Access Compliance Report

Public Rights-of-Way

Intersection ID: 10020376	Main Street: BALLANTYNE CORPORATE PL	Cross Street: N/A	Location: NW
ADA ID: 2E1AAD9B8B11	Ramp Type: Perp	Initial Pass/Fail: Fail	Overall Compliance: No
		Severity Score: 10

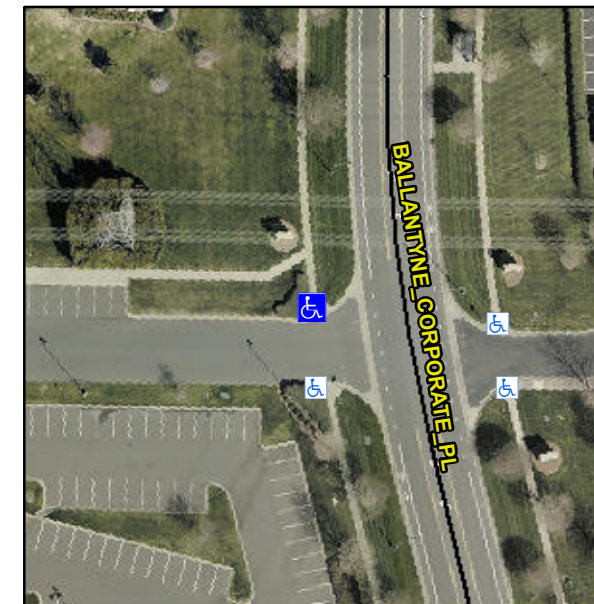
Not Found, R304.5.1, R304.5.3

Compliance	Description	Data	Compliance	Description	Data
N/A	Ramp Length (in)	59.0	Yes	Ramp Slope (%)	6.0
No	Ramp Width (in)	40.0	No	Ramp XSlope (%)	3.9
N/A	Flare Type LT	N/A	N/A	Flare Type RT	N/A
N/A	Flare Slope LT (%)	N/A	N/A	Flare Slope RT (%)	N/A
N/A	Flare Traversable LT?	N/A	N/A	Flare Traversable RT?	N/A
N/A	Landing Length (in)	N/A	N/A	DWS Provided?	N/A
N/A	Landing Width (in)	N/A	N/A	DWS Contrast?	N/A
N/A	Landing Slope (%)	N/A	N/A	DWS Length (in)	N/A
N/A	Landing X Slope (%)	N/A	N/A	DWS Full Width?	N/A
N/A	Landing Curb? (Y/N)	N/A	N/A	DWS Offset (in)	N/A
N/A	Shared Landing?	N/A			
N/A	Gutter Ponding?	N/A	N/A	Gutter Slope (%)	N/A
N/A	Gutter Lip Ht (in)	N/A	N/A	Gutter X Slope (%)	N/A
N/A	Painted X Walk1?	No	N/A	Painted X Walk2?	N/A
	X Walk 1 Direction	To S		X Walk 2 Direction	N/A
N/A	X Walk 1 Width (in)	N/A	N/A	X Walk 2 Width (in)	N/A
	X Walk 1 Slope (%)	0.1		X Walk 2 Slope (%)	N/A
	X Walk 1 X Slope (%)	1.6		X Walk 2 X Slope (%)	N/A

Remove & Replace Entire Ramp.
